Application of Lazer Broadcasting Corporation
For Minor Modification of
KXRS(FM), Hemet, California

File No. BPH-20040205AAK
Facility ID No. 36829

PETITION FOR RECONSIDERATION

ENGINEERING STATEMENT
in support of a
PETITION FOR RECONSIDERATION
prepared for
LBI Radio License Corp.

FIGURE 1 **INTERFERENCE TO KBUE(FM)** **FROM KXRS(FM) CONSTRUCTION PERMIT**

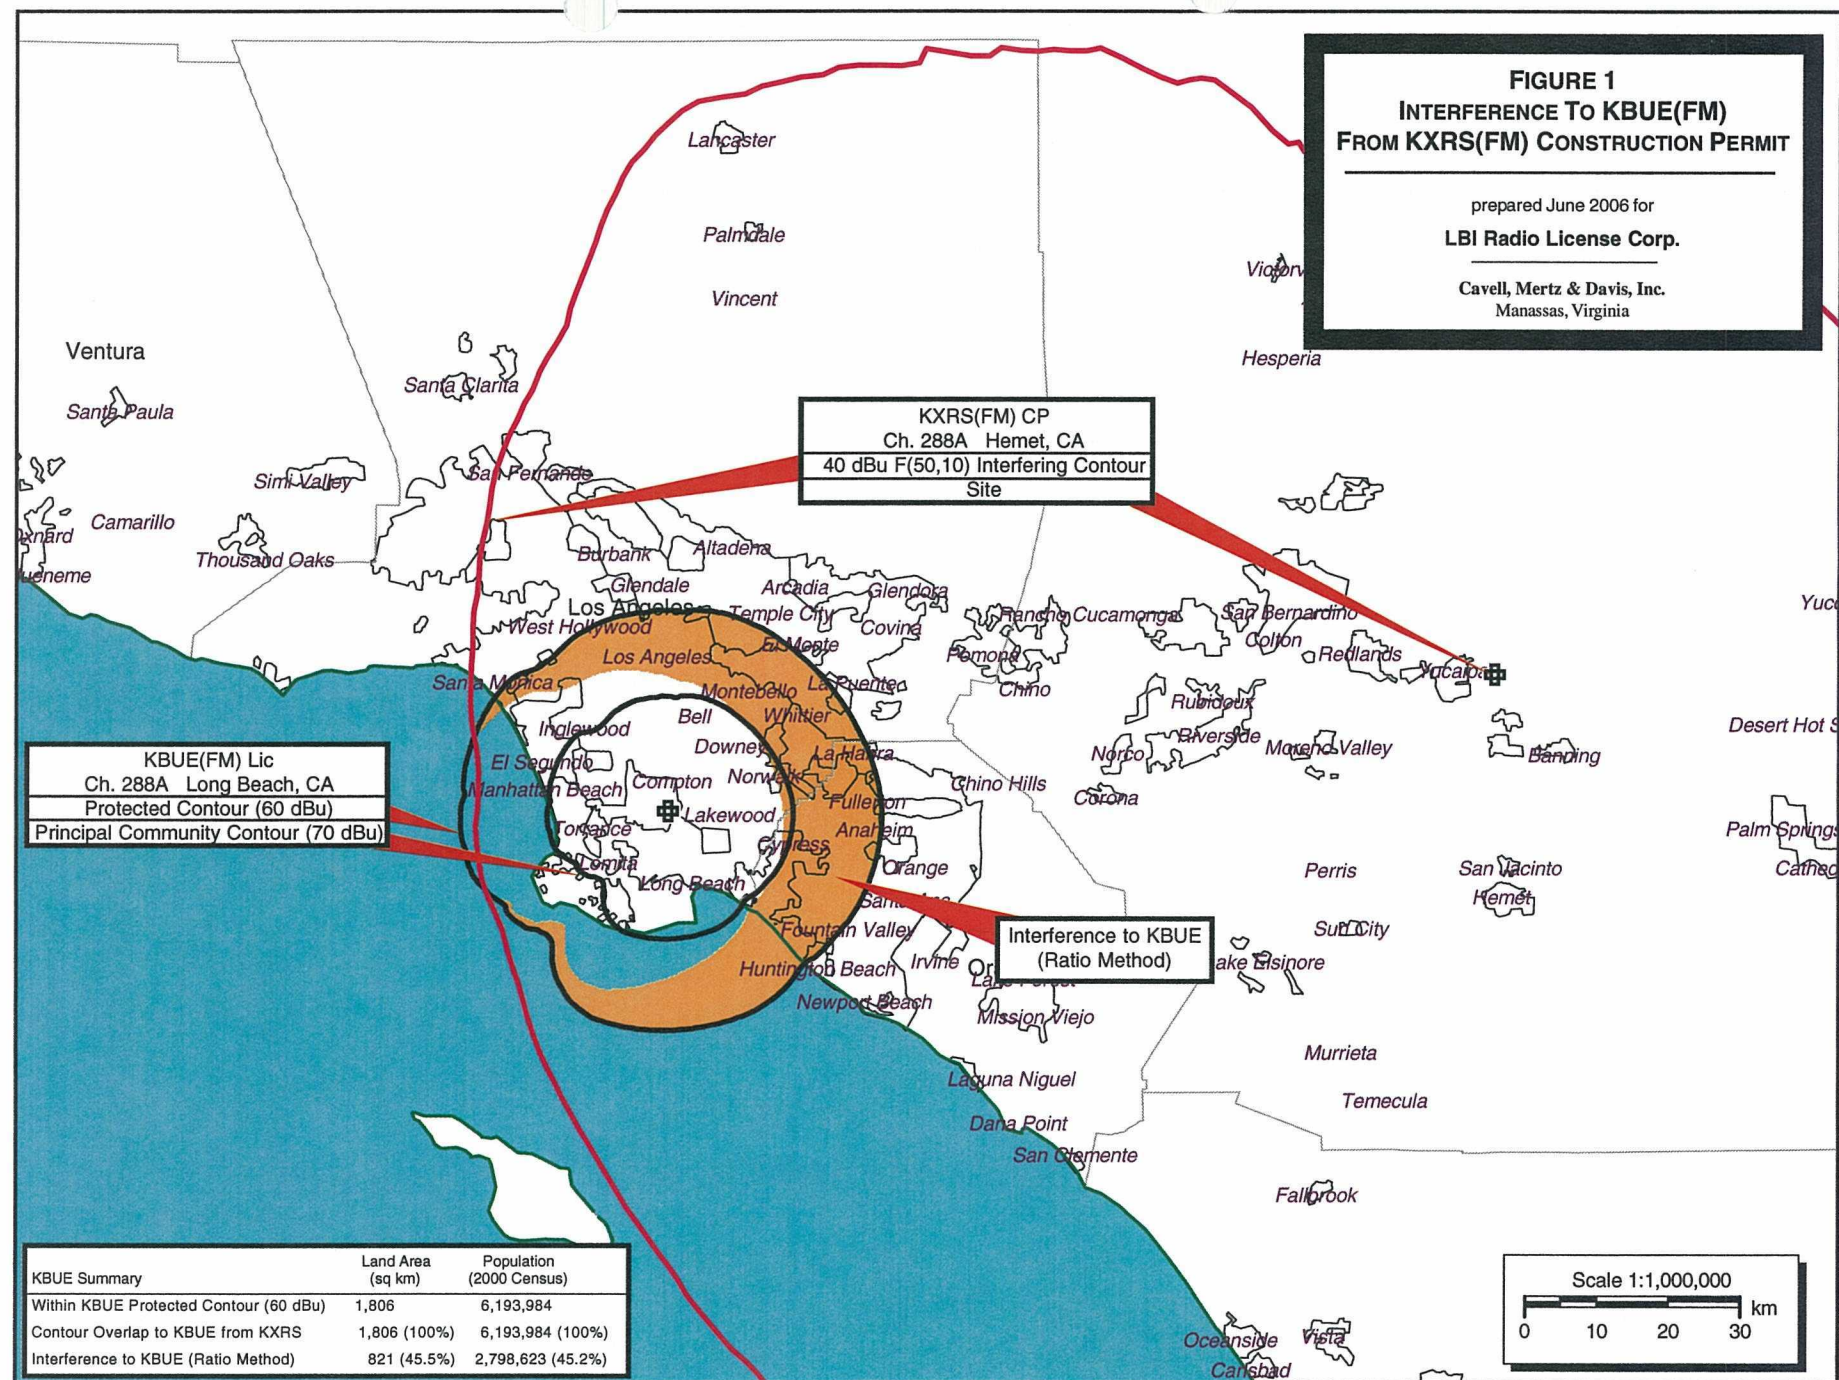
dBu contour will be encompassed by the KXRS interfering contour.⁷ Using the FCC's "undesired-to-desired" signal strength ratio, the modified KXRS facilities are predicted to cause interference to 45.2 percent of the population, and 45.5 percent of the area, within KBUE's 60 dBu contour.⁸ Although the protected contour of the modified KXRS facility would cover an additional 1,922,859 persons, the loss in service to KBUE would affect 2,798,623 persons, for an overall loss in aural service to 875,764 persons.⁹ This substantial degree of interference is due to the location of KXRS' new transmitter site on a mountain slope, which allows KXRS to factor the negative heights above average terrain in some directions (toward the rising mountain) into its overall height above average terrain, thereby allowing an increase in antenna height so great that KXRS – a Class A station – exceeds the contour distances for *Class B* stations in the azimuths towards KBUE.¹⁰

The attached **Figure 1** provides a map depicting the KBUE protected contour (60 dB μ) along with the interfering 40 dB μ F(50,10) contour from the co-channel KXRS CP facility. No overlap of these contours would be permitted under §73.215 if that rule section were applicable to the KXRS CP facility. As demonstrated on **Figure 1**, all land area and all population within the KBUE protected contour is encompassed by the KXRS CP interfering 40 dB μ F(50,10) contour, thus

Figure 1 also depicts the predicted area of interference to KBUE (tinted orange) as derived using the undesired-to-desired ("U/D") signal strength "ratio" method of determining the area subject to interference. The "ratio" method is specified in §73.213(a) regarding modifications to so-called grandfathered short-spaced stations. Using this method, the interference caused by KXRS to KBUE would affect 2,798,623 persons, which is 45.2 percent of the 6,193,984 total population within the KBUE 60 dB μ contour (2000 Census). The land area subject to interference consists of 821 sq. km, which is 45.5 percent of the total land area (1806 sq. km) within the KBUE 60 dB μ contour. The interference area would extend so deep into the KBUE service area that it encompasses an area of 60,041 persons within the KBUE 70 dB μ principal community contour.

FIGURE 2
ALLOCATION SPACING MAP
KXRS(FM) CH. 288A HEMET, CA

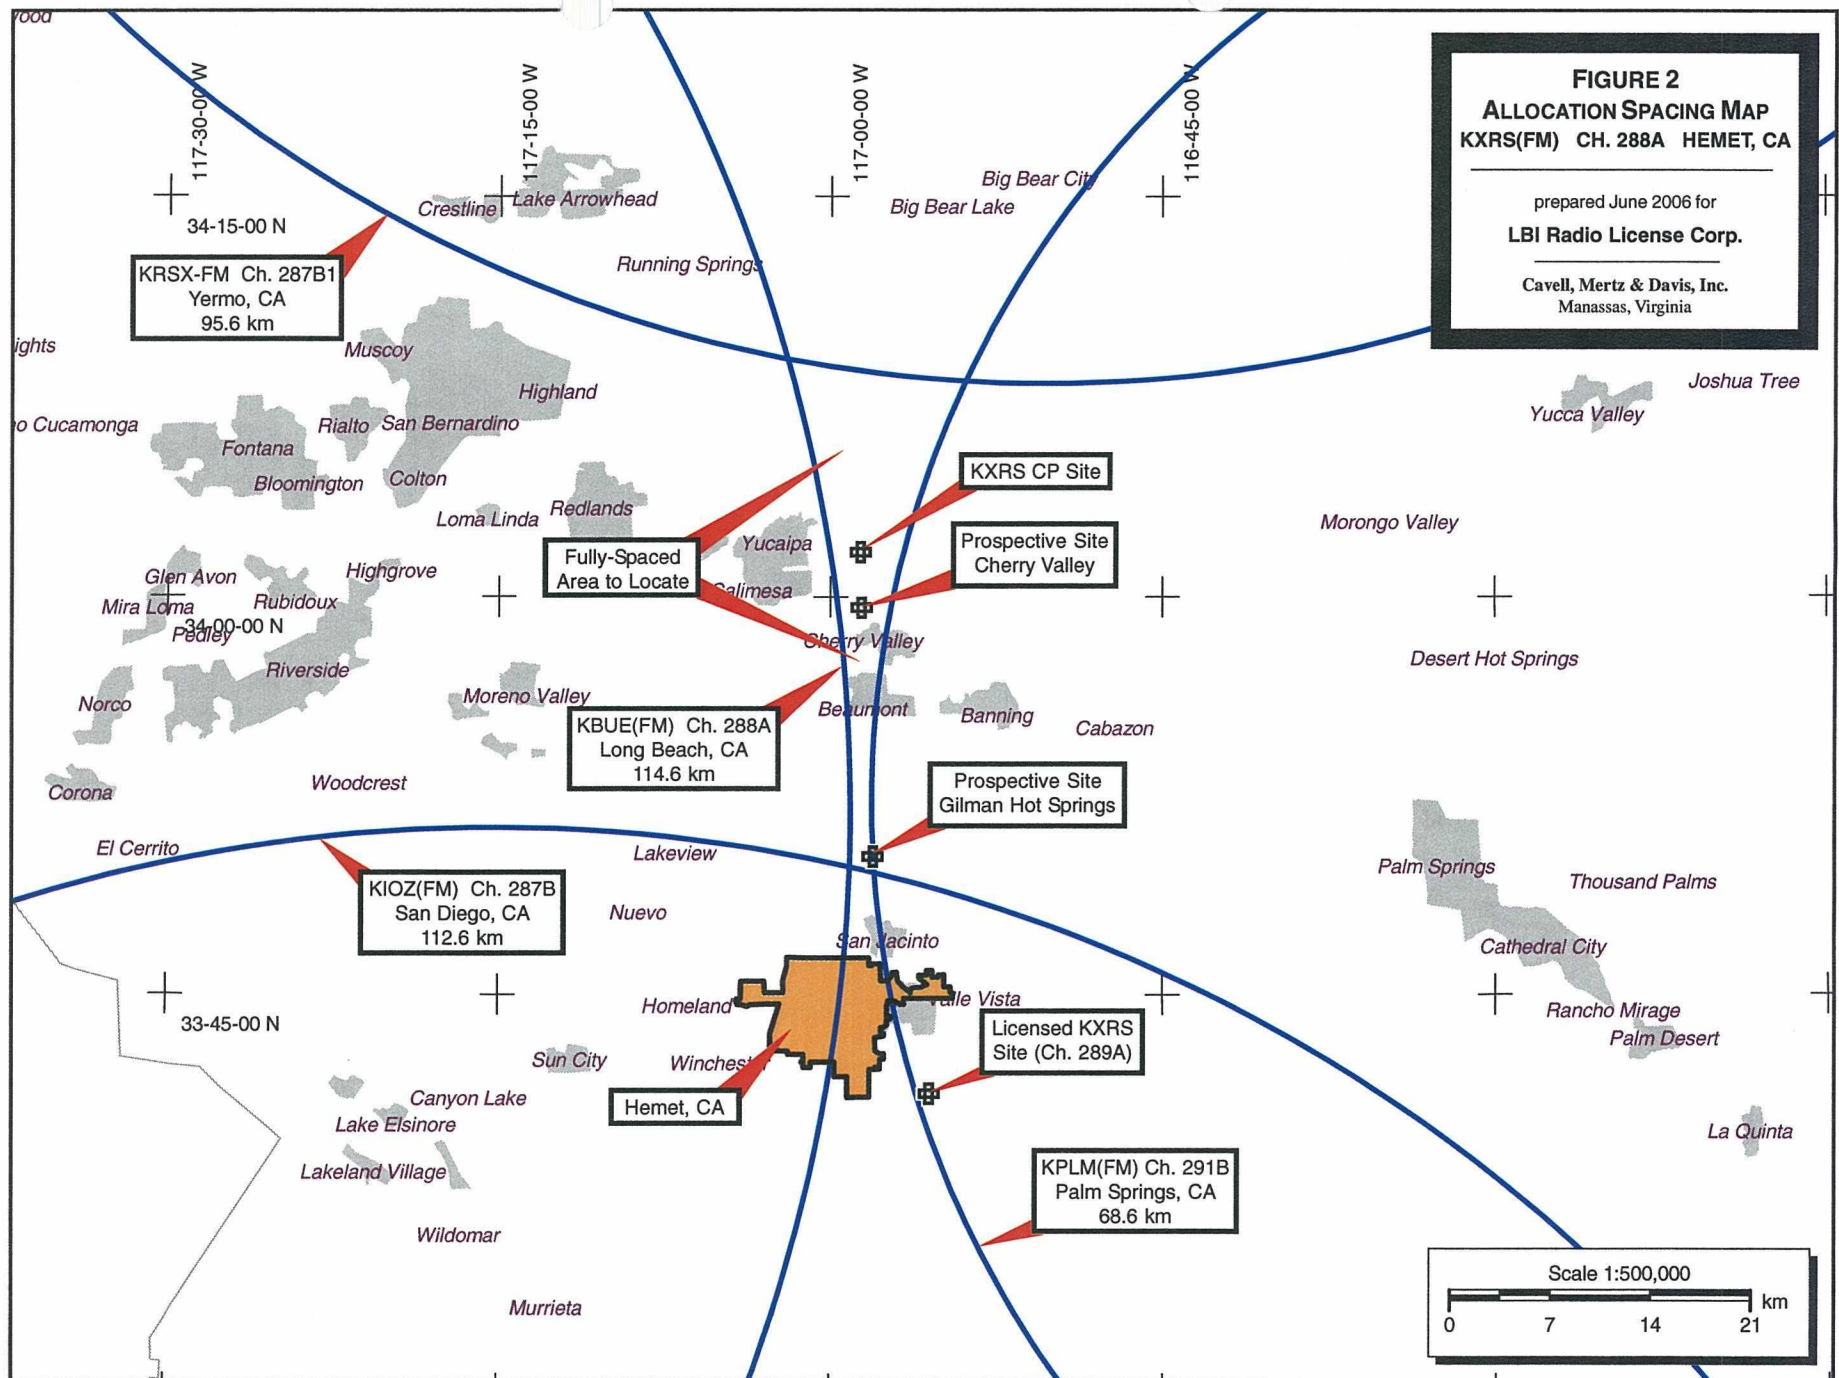
Moreover, as shown in the attached *Engineering Statement*, there is an alternative site from which KXRS could operate on Channel 288A while causing significantly less interference to KBUE.¹¹ From a site located at Gilman Hot Springs on a ridge overlooking Hemet, KXRS would be predicted to cause interference to only 4.2 percent of the population served by

A map is attached as **Figure 2** depicting the “area to locate” KXRS on Channel 288A based on the standard spacing requirements of §73.207 and distance rounding per §73.208(c). The “area to locate” area includes a portion of the mountain ridge overlooking Hemet. This ridge is the partial terrain obstruction into Hemet from the KXRS CP site (as discussed in LBI’s *Informal Objection*). Two fully spaced prospective alternate sites for KXRS are identified on the map that would result in appreciably less interference to KBUE.

A prospective fully-spaced site on the ridge overlooking Hemet is identified and referred to herein as the “Gilman Hot Springs Site.” Another terrain peak located near Cherry Valley would also comply with FCC spacing requirements. The Cherry Valley site is partially terrain-blocked into Hemet, similar to KXRS CP site that the Commission found to be acceptable. The Cherry Valley site was once authorized as a transmitter site for station KWIE(FM) (Ch. 241A, San Jacinto, CA).² Technical facility data for each of these prospective transmitting locations for KXRS is summarized in the attached **Tables 2** and **3**. Each prospective site could be employed as a maximum Class A
